# Access Compliance Report

## Public Rights-of-Way

| Intersection ID: 48942                  | Main Street: MITCHELL_GRANT_WY | Cross Street: MORGAN_LEE_AV             | Location: E            |
| ADA ID: A60BC9A0B0C4                    | Ramp Type: BlendTrans1         | Initial Pass/Fail: Fail                 | Overall Compliance: No |

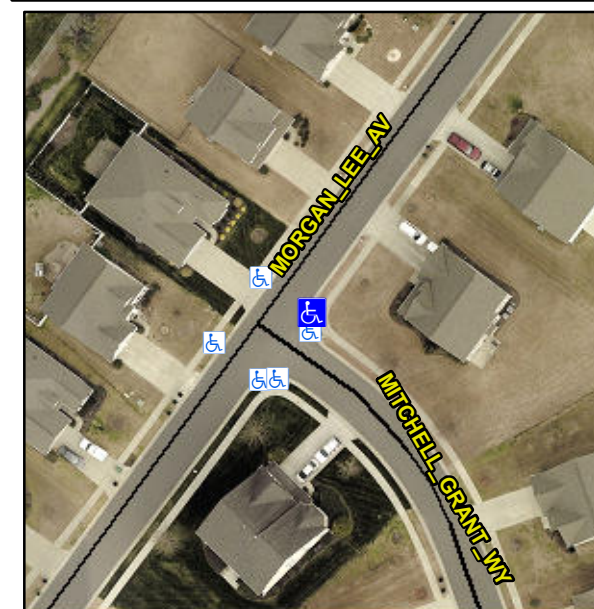
**CURB GAP 1.0, CURB WIDTH 46.0**

**Not Found, R304.5.1**

| Compliance | Description           | Data  | Compliance | Description                 | Data |
|------------|-----------------------|-------|------------|-----------------------------|------|
| No         | Ramp Width (in)       | 47.0  | Yes        | BlendTrans XSlope (%)       | 1.0  |
|            |                       |       | No         | Curb Slope (%)              | 14.3 |

**Remove & Replace Curb Ramp With Two New Directional Ramps or Equivalent.**
